Subject: WO-LT-0082 Engineering Support for Vertical Structures Construction
Sabez School, Adraskan District, Herat Province– Design Review

This memo addresses a request from USAID to Tetra Tech to review the proposed Sabez School design for conformance with the International Building Code's (IBC) structural and seismic requirements. This review provides an overall design review of the proposed Sabez School located in the Herat Province, Adraskan District, Afghanistan.

SHEET NO: S 02

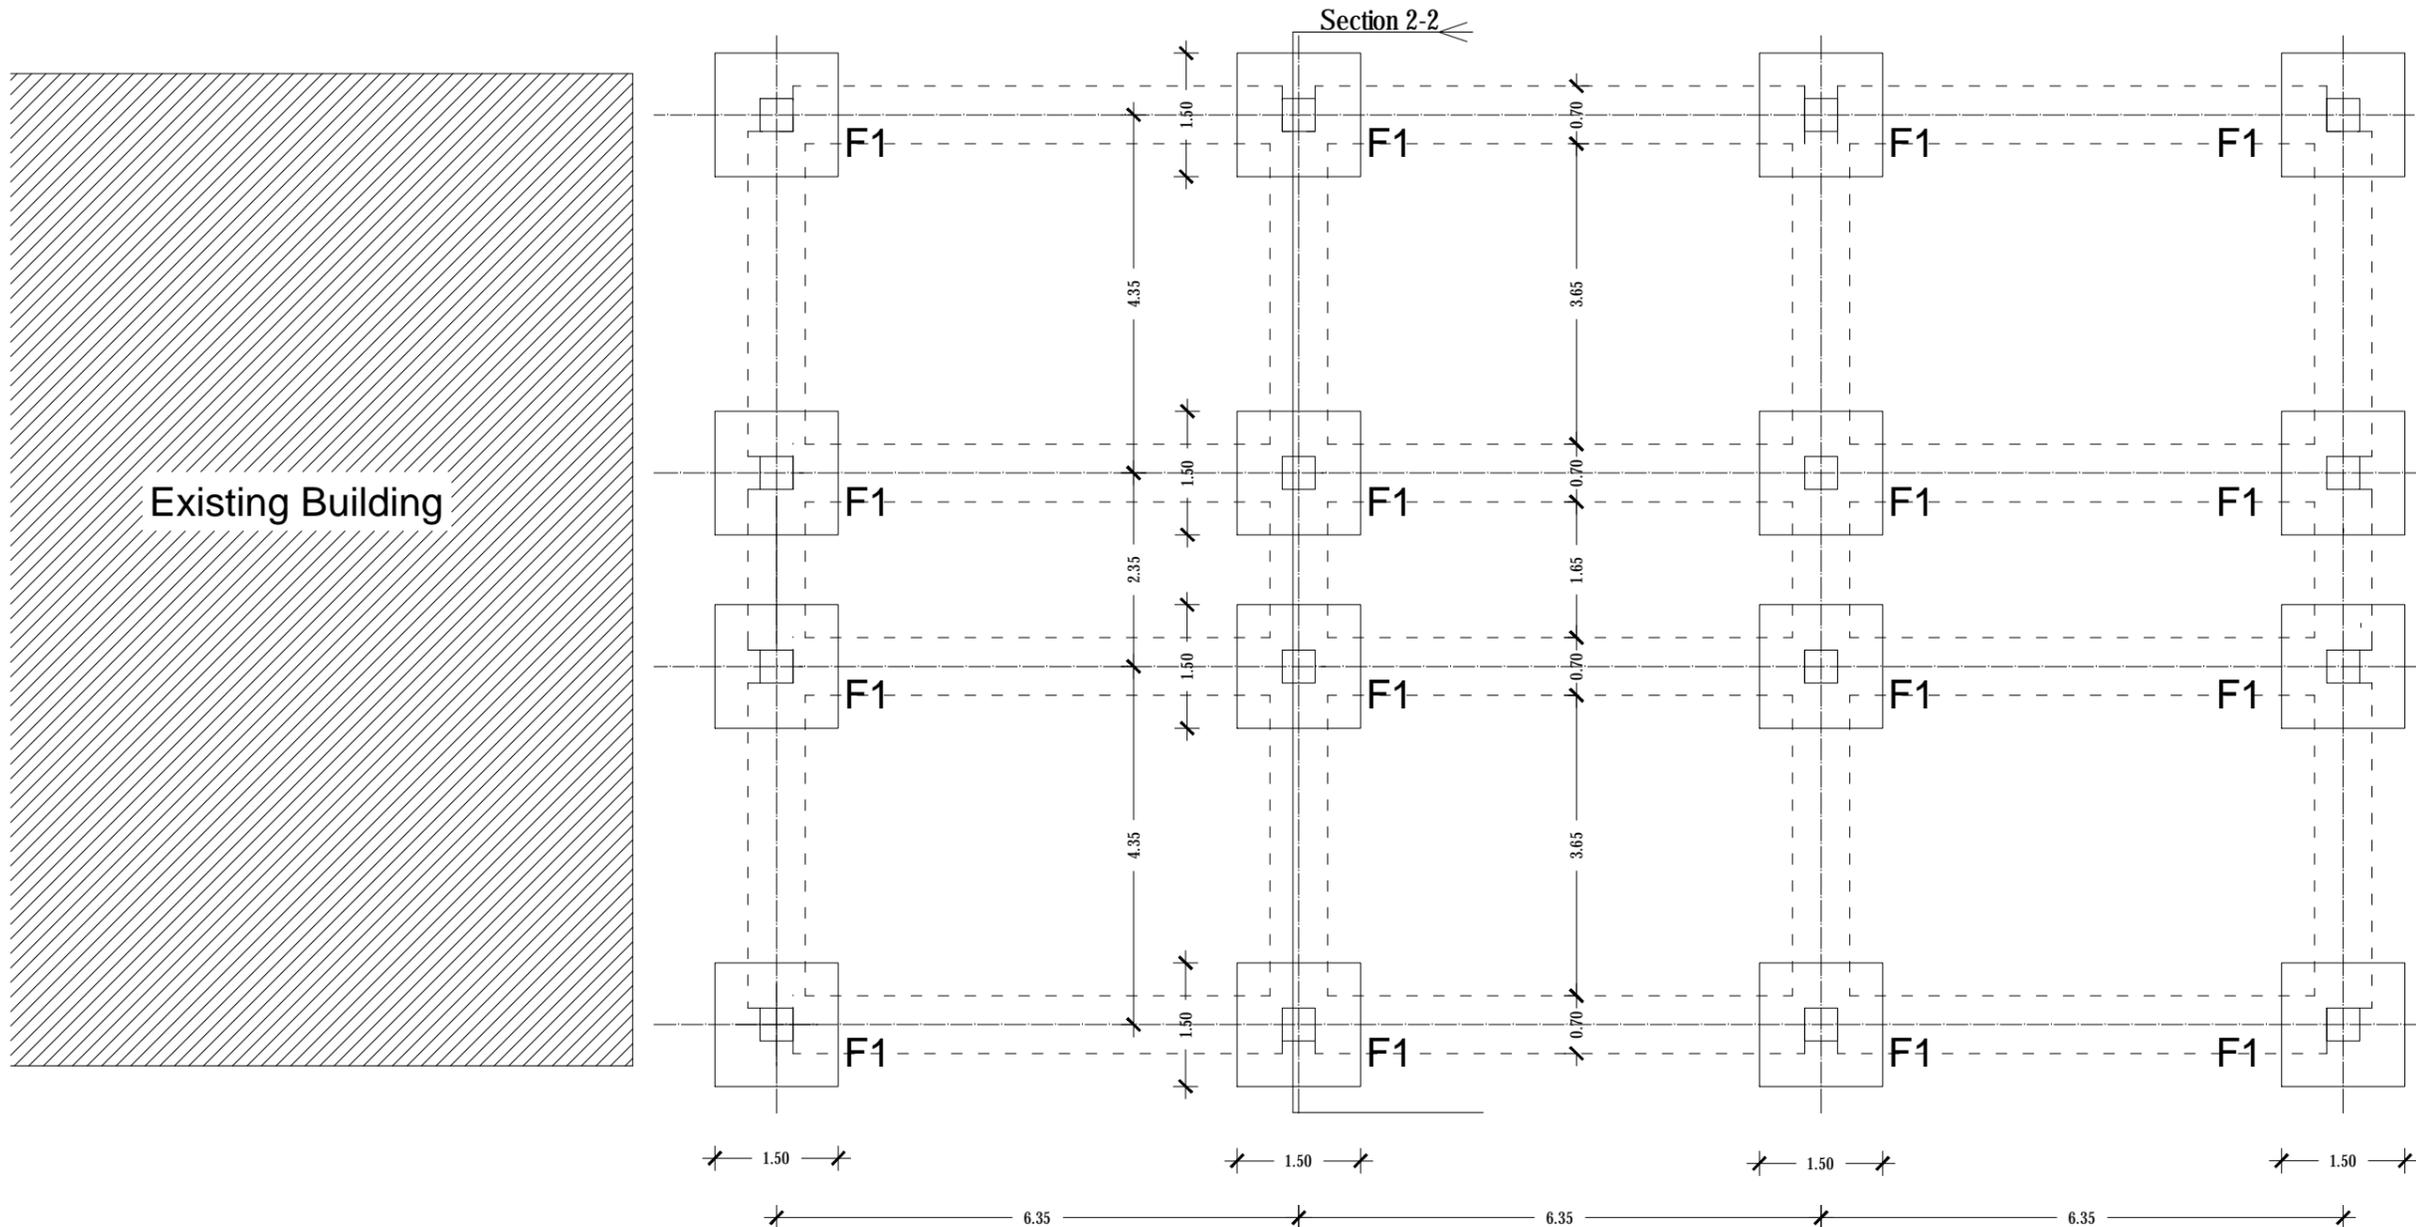
- Structural Drawings
 - Sheet S00 – The general notes do not include Design Loads or the structural system.
 - Sheet S00 has conflicting information regarding the bottom of footing elevation (See Note A2 on Sheet S00 and elevations noted throughout the plan set)
 - Sheet S00 indicates inconsistent codes to be used. For instance, ACI318 08 was used for reinforced concrete design, but ACI318-05 was indicated for Steel Reinforcement.
 - S00 title block is upside down.
 - S00 - Splice lengths for reinforcement bars larger than No. 22 are incorrect.
 - S02 Grid line dimensions conflict with S03, S04 and S08. S02 dimensions are used in the model.

- Slab-on grade layout on S02 Foundation plan is inconsistent with section cuts throughout the plan set. Grade beam elevations are not apparent.
- S06 – 01 beam 2 section: Not clear if concrete beam top reinforcement is continuous.

**01 COLUMN AND FOOTING
SECTION**
SCALE:NTS

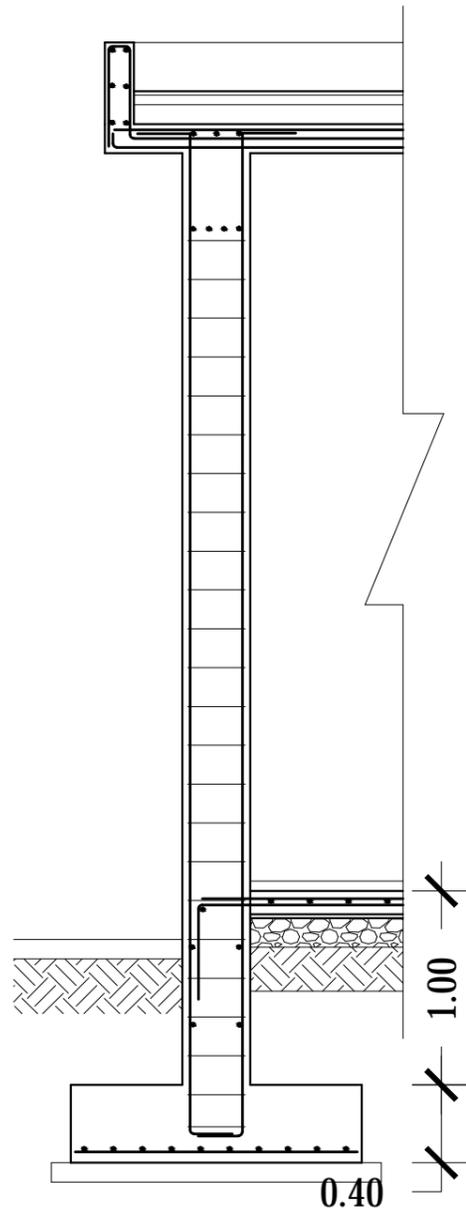
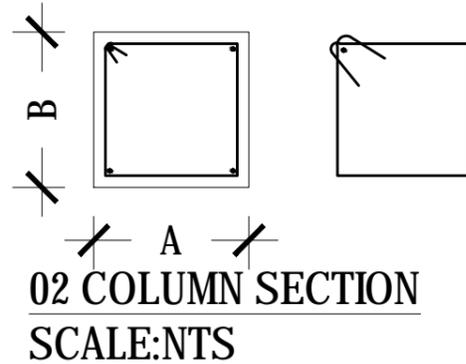
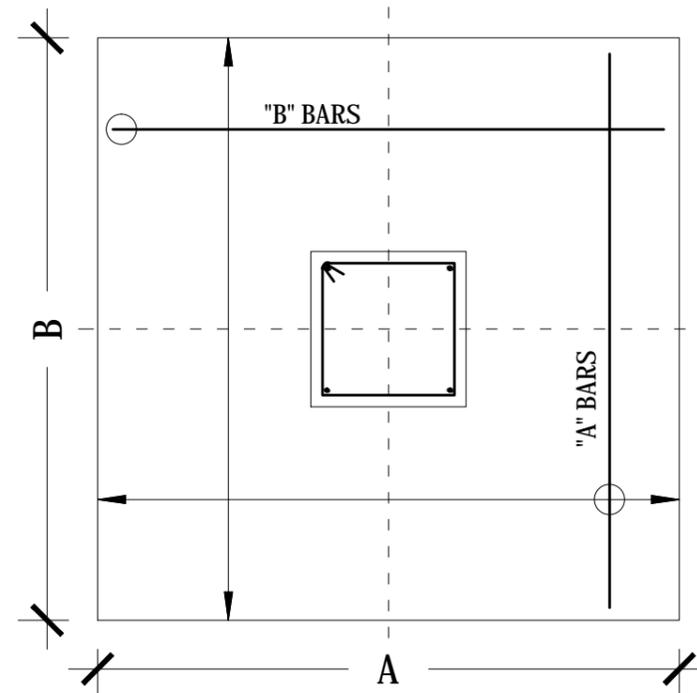
- S07 – 01 column and footing section: Column Rebar splice locations are not indicated.
- S07 – 01 column and footing section: At Column to beam connection: Column dowel into beam is not specified.

- S07 – 01 column and footing section: Starting point for column ties is not specified.
- Missing parapet detail.
- Rebar callouts are not correct. The standard practice is bar diameter @ Spacing or number of bars and the bar diameter.

- The Longitudinal reinforcement provided does not meet the minimum reinforcement required (ACI 318-11 Sec. 10.9.1)
 - The transverse reinforcement does not meet the minimum size requirements (ACI 318-11 Sec. 7.10.5.1) or requirements for bar spacing (ACI 318-11 Sec. 21.3.4.2)

- Foundation Design
 - The foundations located in the two center rows (along the transverse direction of the building) fail due to exceeding the allowable bearing pressure.
